Product Discontinuation Notice

Issue Date
March, 2023

Pushbutton Switches and Indicators

Recommended Replacement

[Body color]

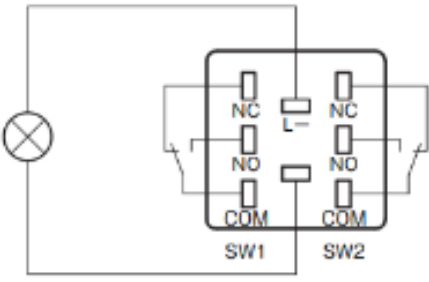
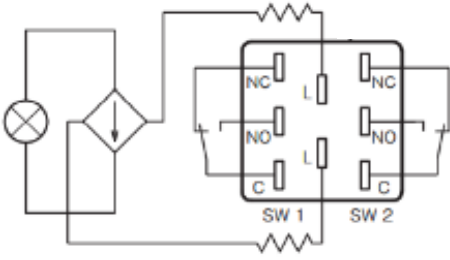
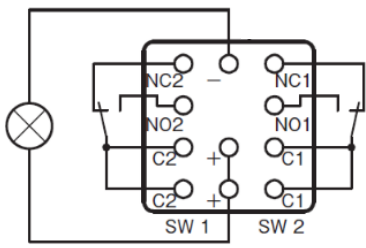
Product discontinuation Model A16-□N□N Model A16□L-□□N	Recommendable replacement Model A16□L-□□□-T□-□								
A16-1NRN A16□L-□RN Light source : Neon lamp <table> <tr> <td>Light OFF</td><td></td></tr> <tr> <td>Light ON</td><td></td></tr> </table>	Light OFF		Light ON		A16□L-□R□-T1-□ Light source : LED It will be brighter than a neon lamp. <table> <tr> <td>Light OFF</td><td></td></tr> <tr> <td>Light ON</td><td></td></tr> </table>	Light OFF		Light ON	
Light OFF									
Light ON									
Light OFF									
Light ON									
A16-1NGN A16□L-□GN Light source : Neon lamp <table> <tr> <td>Light OFF</td><td></td></tr> <tr> <td>Light ON</td><td></td></tr> </table>	Light OFF		Light ON		A16□L-□G□-T1-□ Light source : LED It will be brighter than a neon lamp. <table> <tr> <td>Light OFF</td><td></td></tr> <tr> <td>Light ON</td><td></td></tr> </table>	Light OFF		Light ON	
Light OFF									
Light ON									
Light OFF

Light ON									
A16-2NRN A16□L-□RN Light source : Neon lamp <table> <tr> <td>Light OFF</td><td></td></tr> <tr> <td>Light ON</td><td></td></tr> </table>	Light OFF		Light ON		A16□L-□R□-T2-2S Light source : LED It will be brighter than a neon lamp <table> <tr> <td>Light OFF</td><td></td></tr> <tr> <td>Light ON</td><td></td></tr> </table>	Light OFF		Light ON	
Light OFF									
Light ON									
Light OFF									
Light ON									
A16-2NGN A16□L-□GN Light source : Neon lamp <table> <tr> <td>Light OFF</td><td></td></tr> <tr> <td>Light ON</td><td></td></tr> </table>	Light OFF		Light ON		A16□L-□G□-T2-2S Light source : LED It will be brighter than a neon lamp <table> <tr> <td>Light OFF</td><td></td></tr> <tr> <td>Light ON</td><td></td></tr> </table>	Light OFF		Light ON	
Light OFF									
Light ON									
Light OFF									
Light ON

【Dimensions】

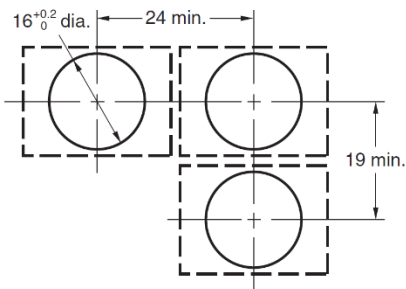
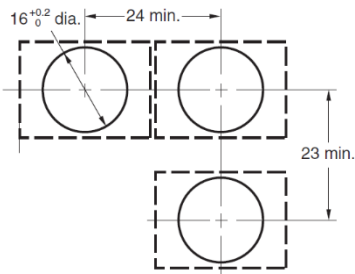
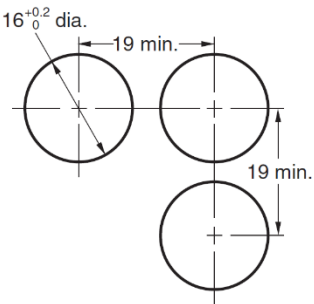
Product discontinuation Model A16-□N□N Model A16□L-□□N	Recommendable replacement Model A16□L-□□□-T□-□
Pushbutton: A16□L-J□N, Lamp: A16-□N□N, Case: A16□-CJ□, Socket: A16-□ Soldering terminal When using a combination 	Set model : A16□L-J□□-T1-□ Soldering terminal The depth from the mounting surface is 21.6mm longer. 
	Set model : A16□L-J□□-T□-2S Quick connector The depth from the mounting surface is 22.4mm longer.
